Sheet No. C0.0

Project Title:
EAST TOWN CROSSING PHASE 1

Project No.
2230752
Issue Set & Date:
PERMIT SUBMITTAL
11/20/2023

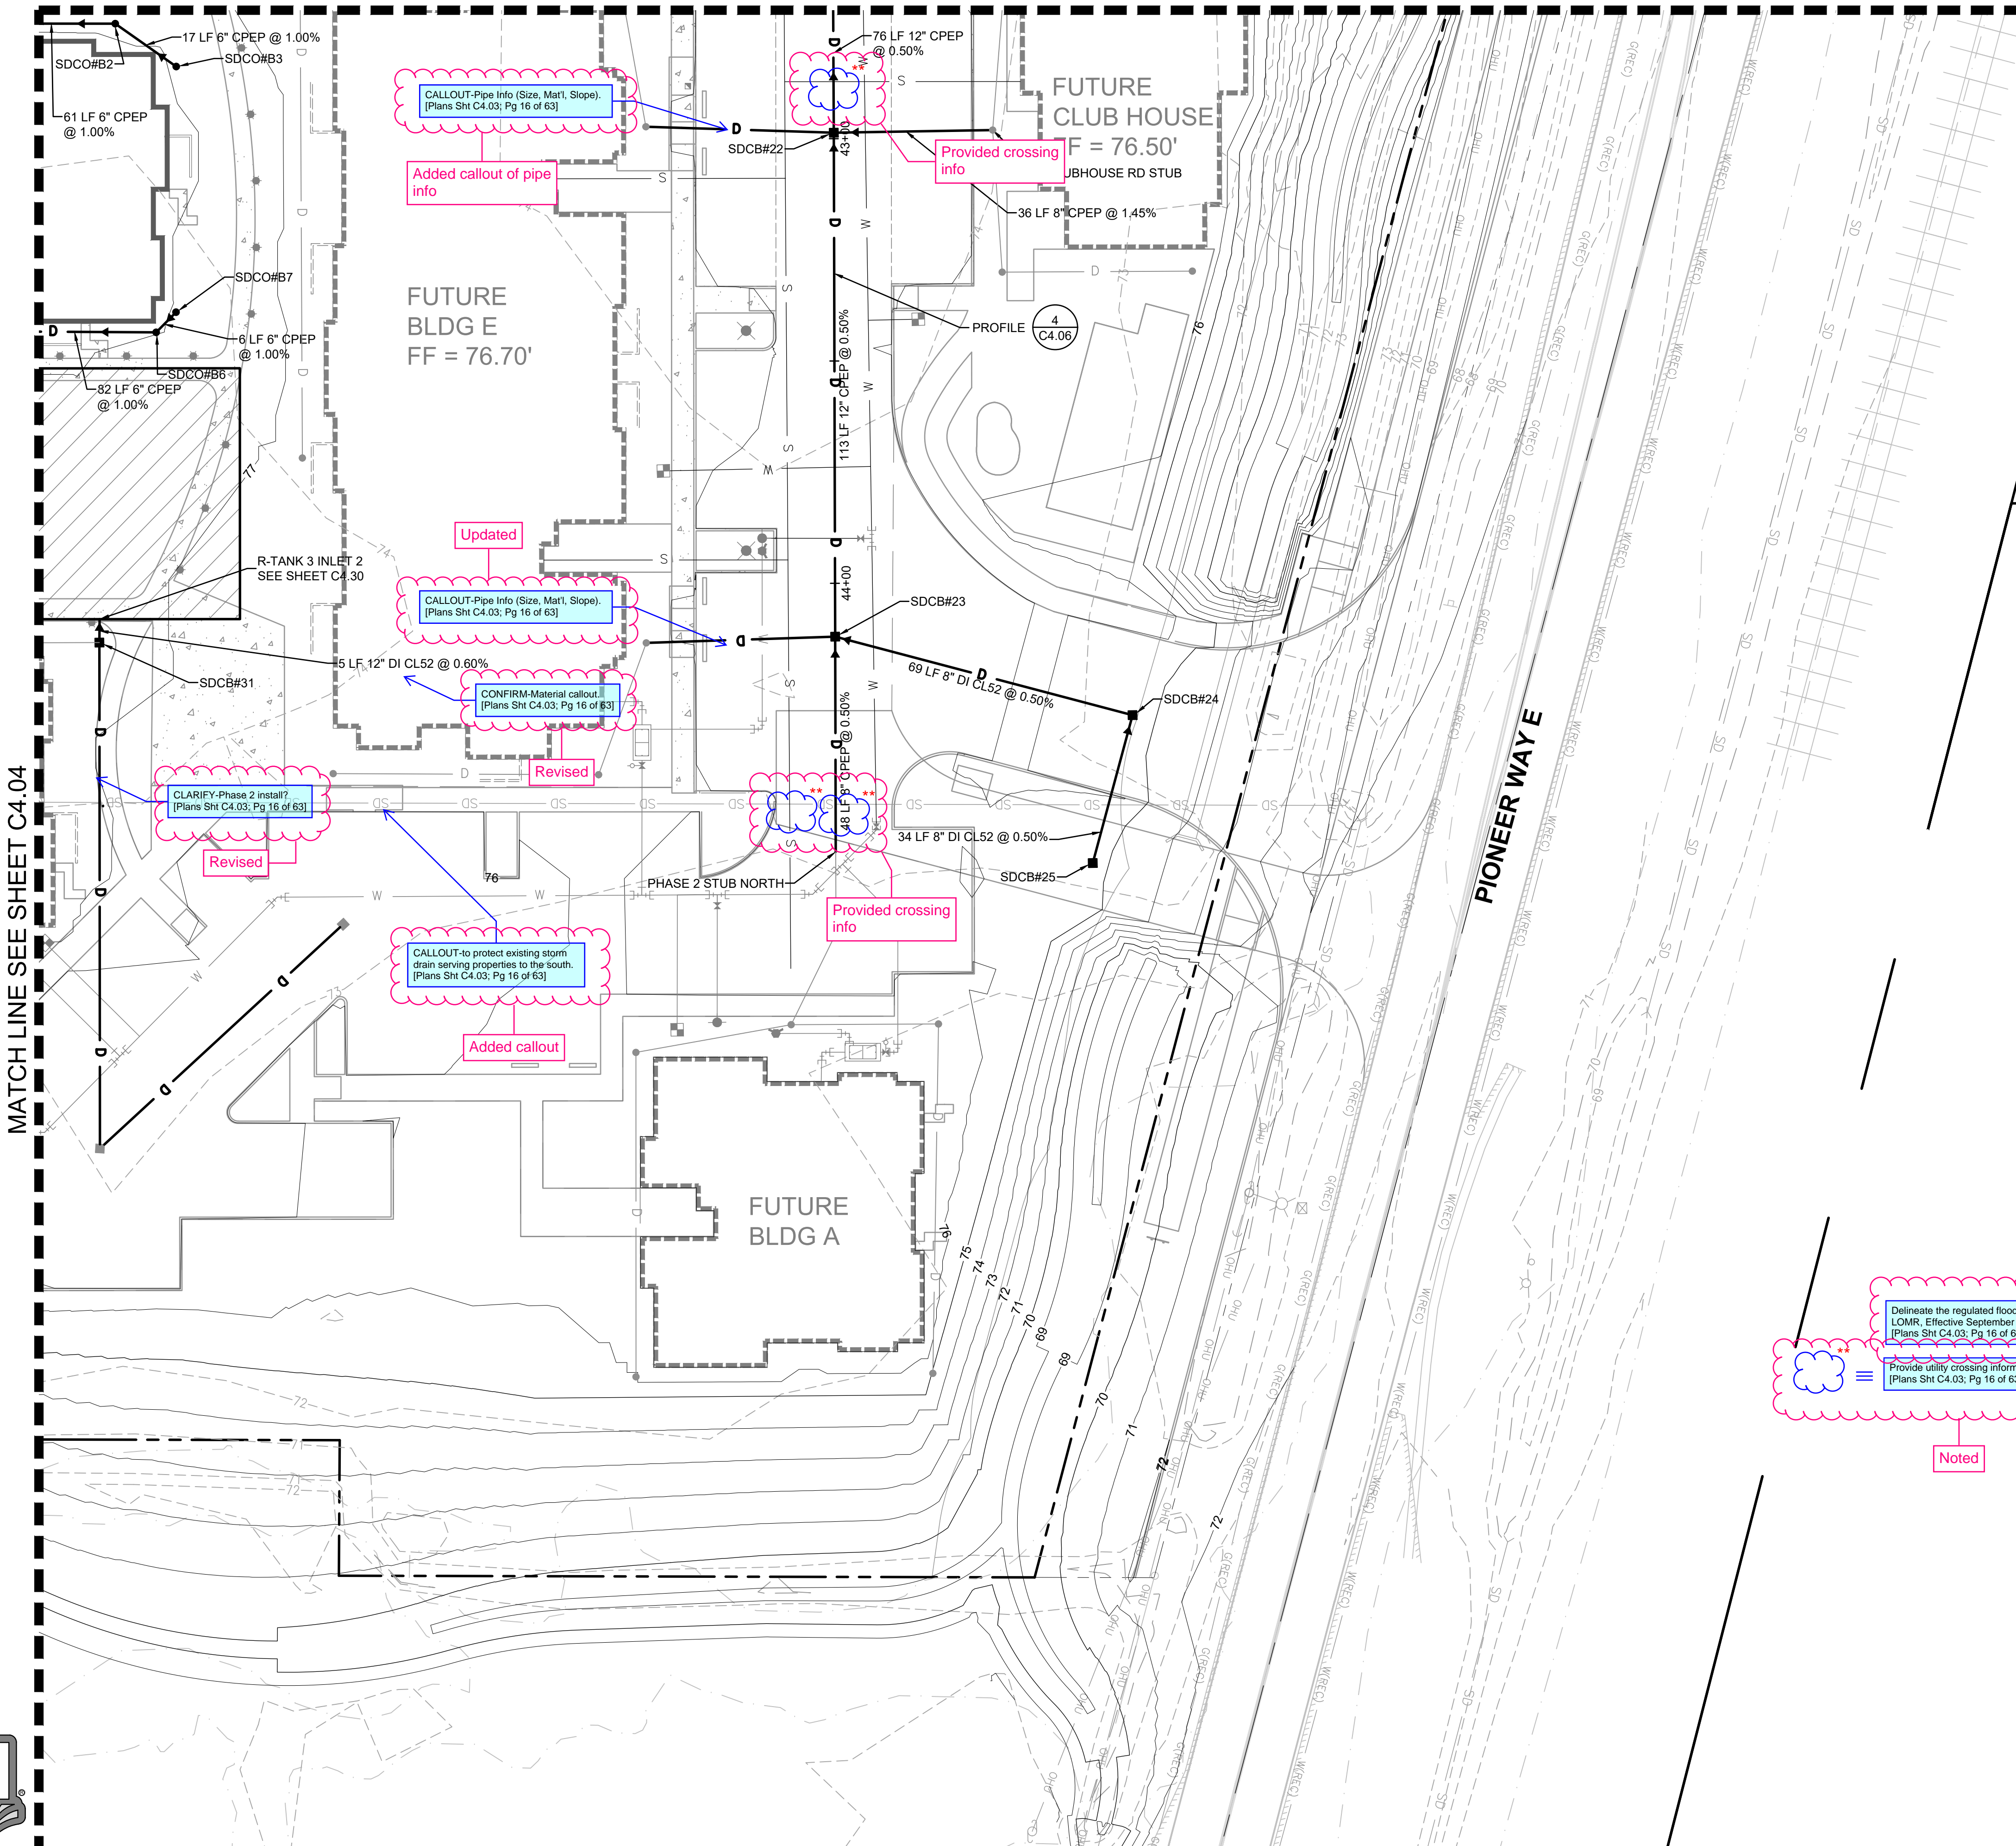
Delineate the regulated floodplain per the LOMR, Effective September 8, 2022. [Plans Sht C4.03; Pg 16 of 63]

Provide utility crossing information [Plans Sht C4.03; Pg 16 of 63]

VERIFY-Sheet callout (C4.07). [Plans Sht C4.03; Pg 16 of 63]

CALLOUT-Pipe Info (Size, Mat'l, Slope). [Plans Sht C4.03; Pg 16 of 63]

Updated
CALLOUT-Pipe Info (Size, Mat'l, Slope). [Plans Sht C4.03; Pg 16 of 63]

CONFIRM-Material callout. [Plans Sht C4.03; Pg 16 of 63]

CLARIFY-Phase 2 install? [Plans Sht C4.03; Pg 16 of 63]

CALLOUT-to protect existing storm drain serving properties to the south. [Plans Sht C4.03; Pg 16 of 63]

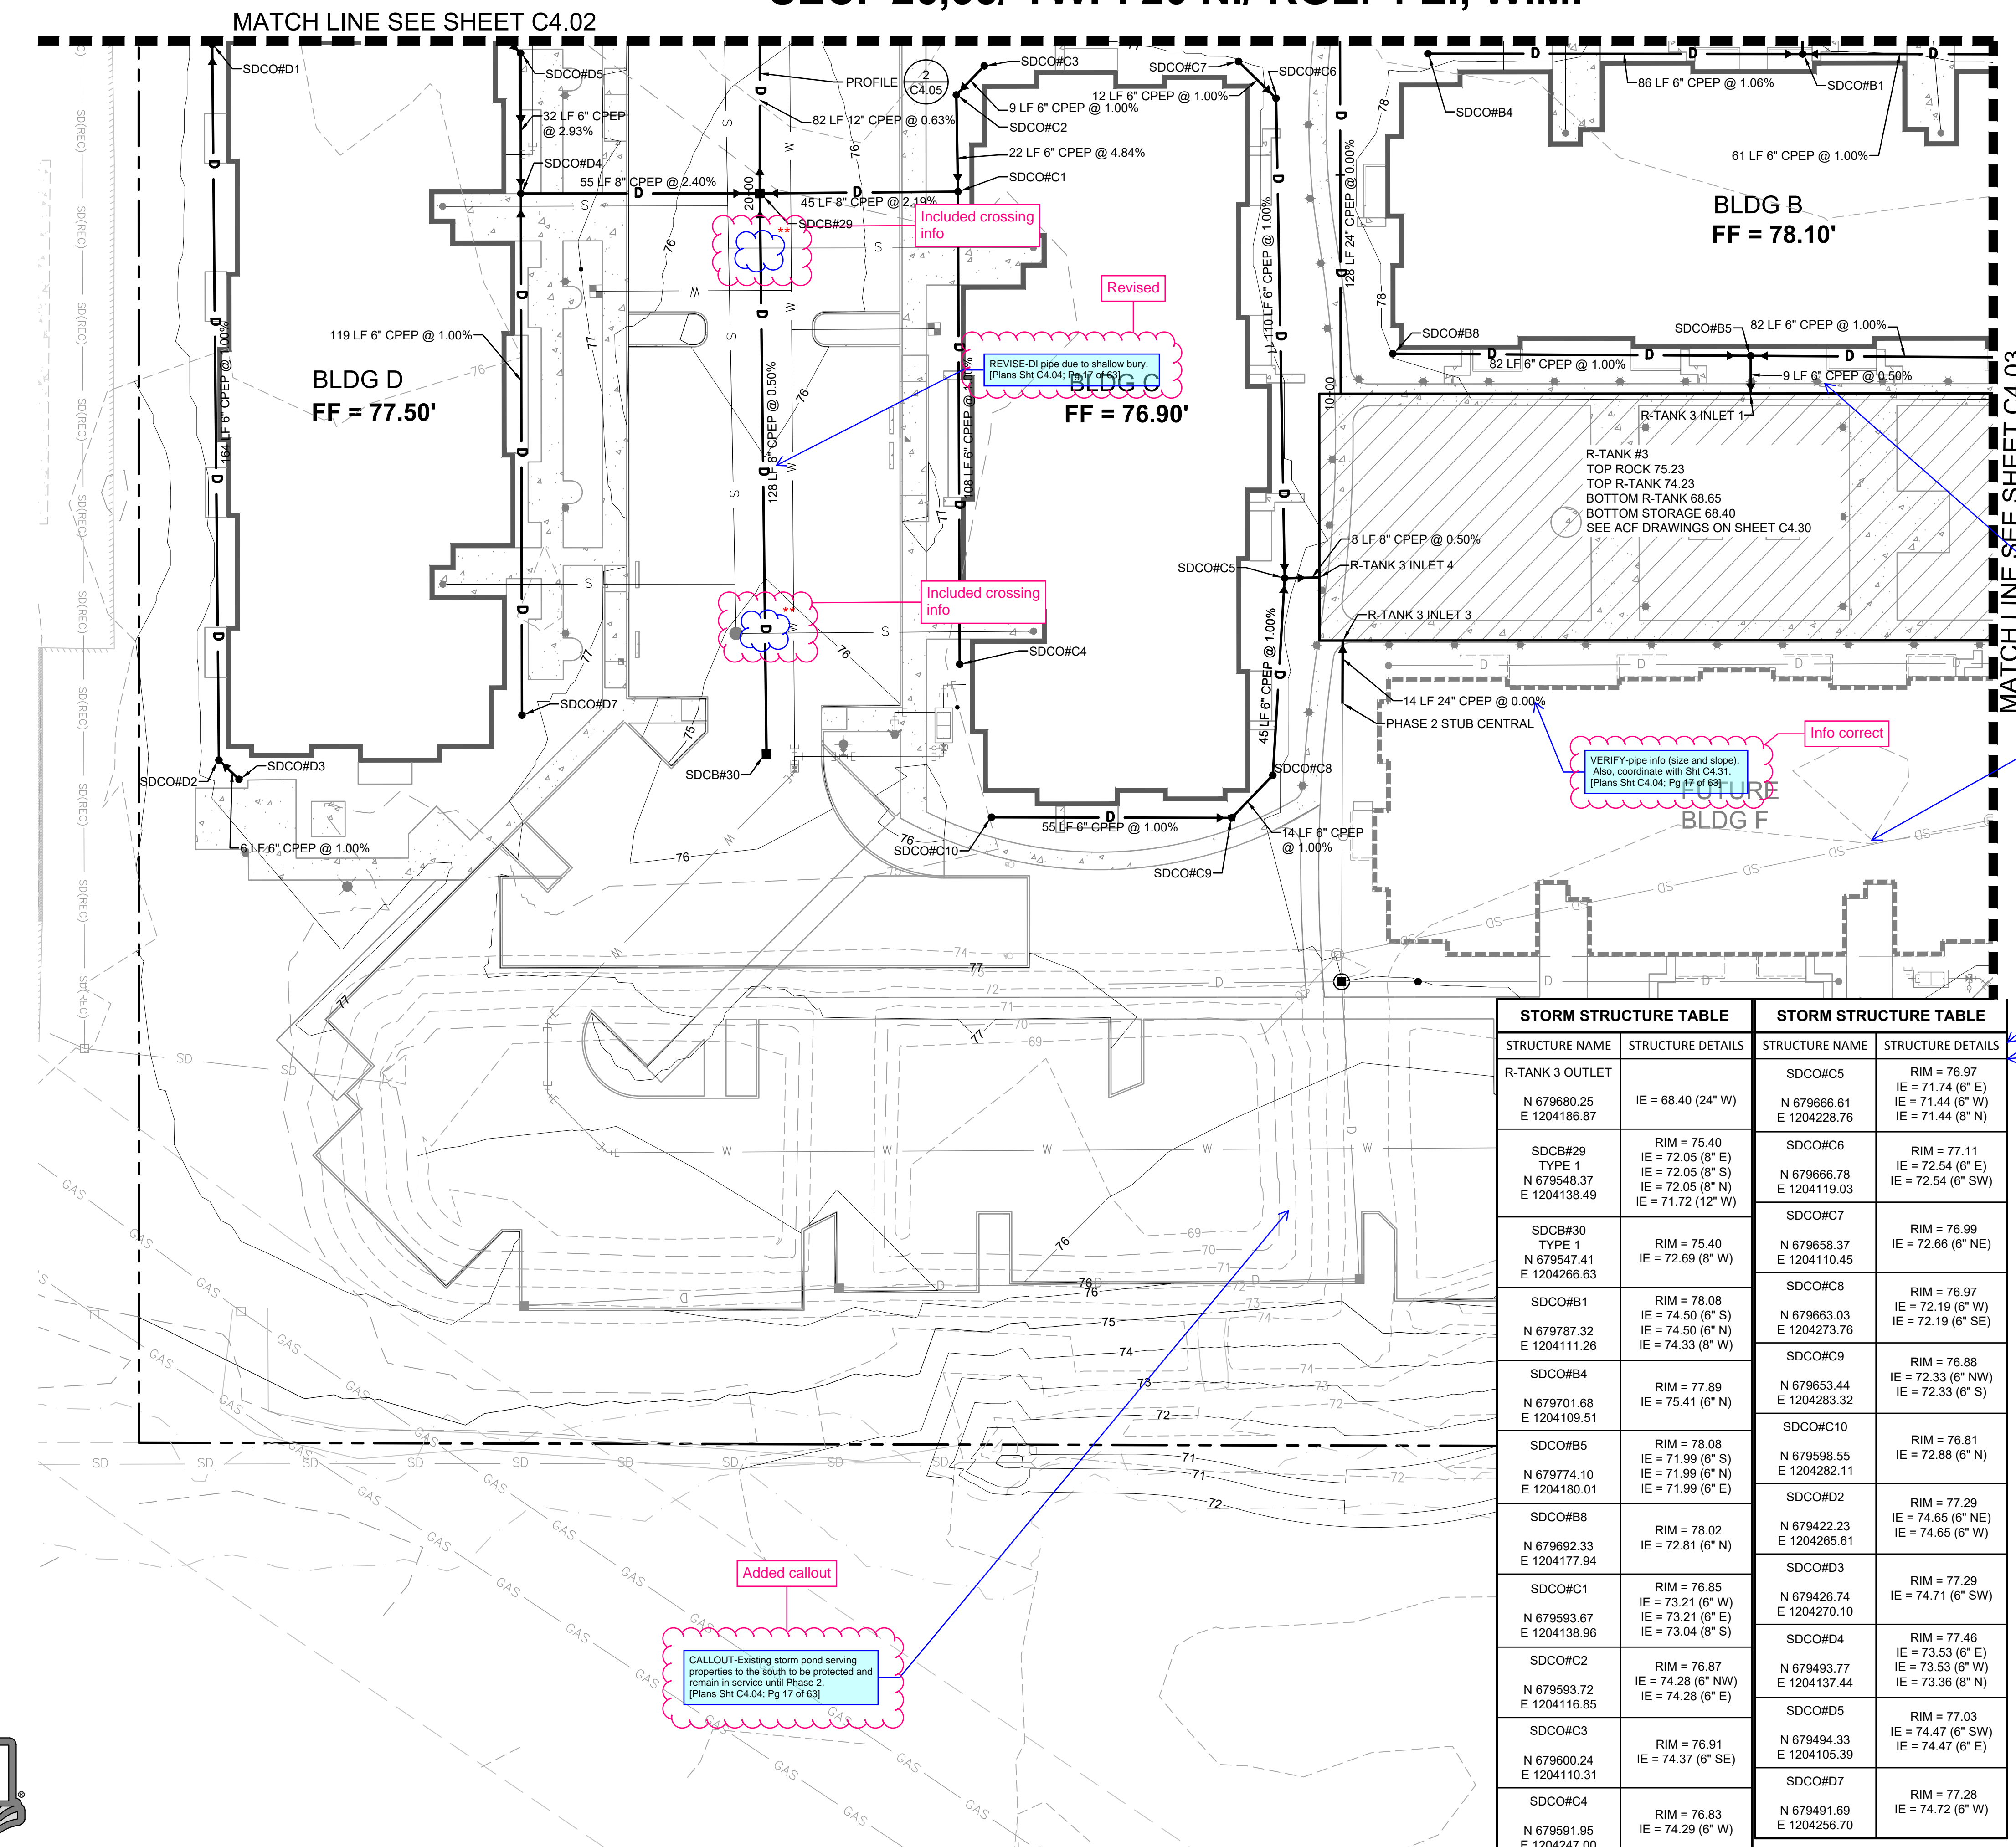
Updated callout
Provide utility crossing information.
[Plans Sht C4.04; Pg 17 of 63]

Correct info
VERIFY pipe size.
[Plans Sht C4.04; Pg 17 of 63]

Called out
CALLOUT to protect existing storm drain serving properties to the south.
[Plans Sht C4.04; Pg 17 of 63]

Added
ADD R-Tank 3 inlets #1, 3, and 4 with IEs.
[Plans Sht C4.04; Pg 17 of 63]

Added
ADD SDCO#D1 structure details.
[Plans Sht C4.04; Pg 17 of 63]

Added callout
CALLOUT-Existing storm pond serving properties to the south to be protected and remain in service until Phase 2.
[Plans Sht C4.04; Pg 17 of 63]

Sheet No.
C4.06
 19 of 63 Sheets

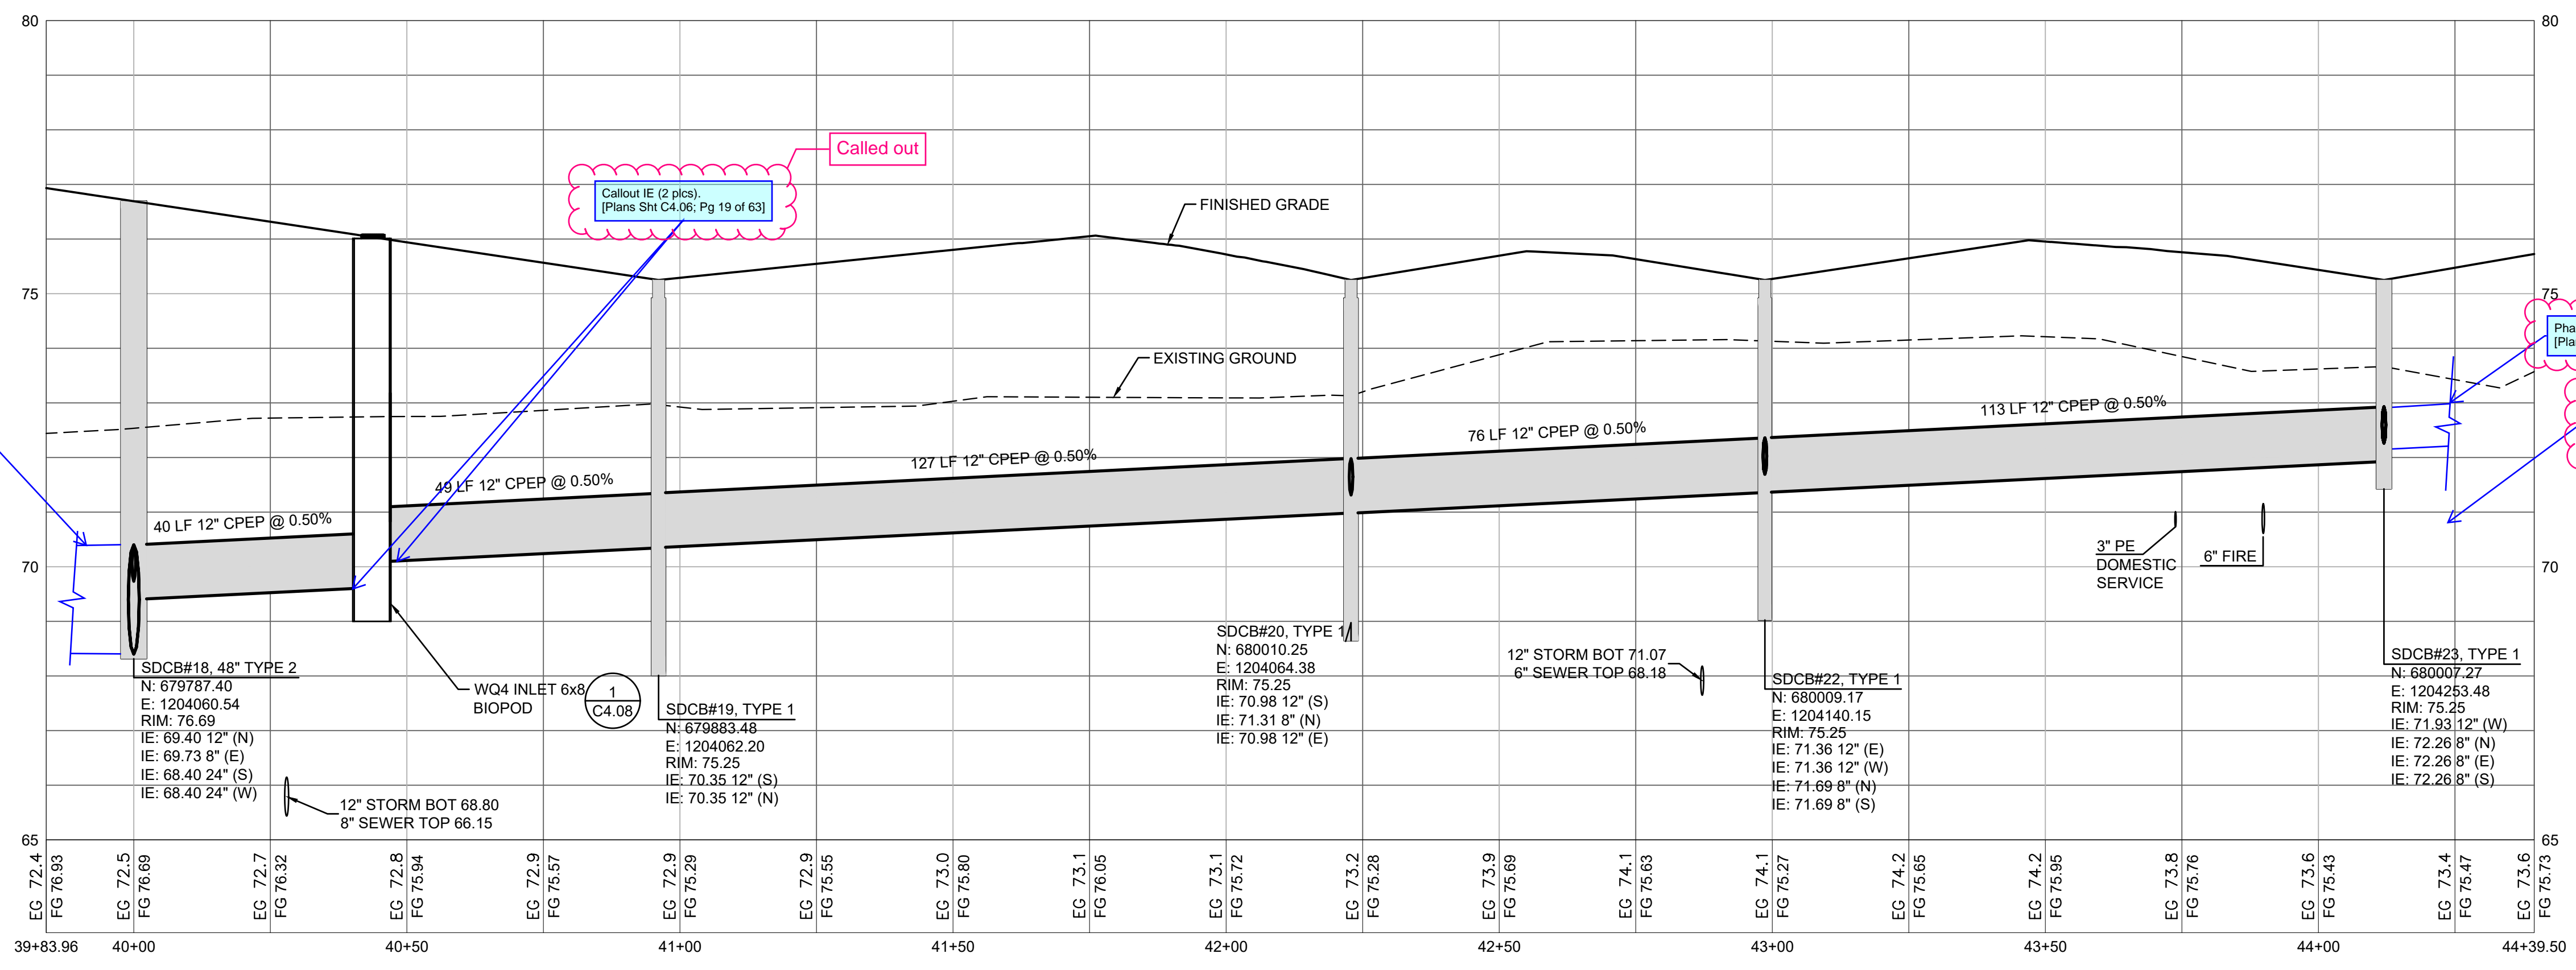
Revised
 Per comments on C4.01, revise to 12" dia. per Shts 204-3/4 (north). [Plans Sht C4.06; Pg 19 of 63]

Pipe to south? [Plans Sht C4.06; Pg 19 of 63]
 Updated

Called out
 Callout IE (2 pics). [Plans Sht C4.06; Pg 19 of 63]

Updated
 Phase 2 Stub? [Plans Sht C4.06; Pg 19 of 63]
 Show existing storm main and provide crossing information. [Plans Sht C4.06; Pg 19 of 63]
 Updated
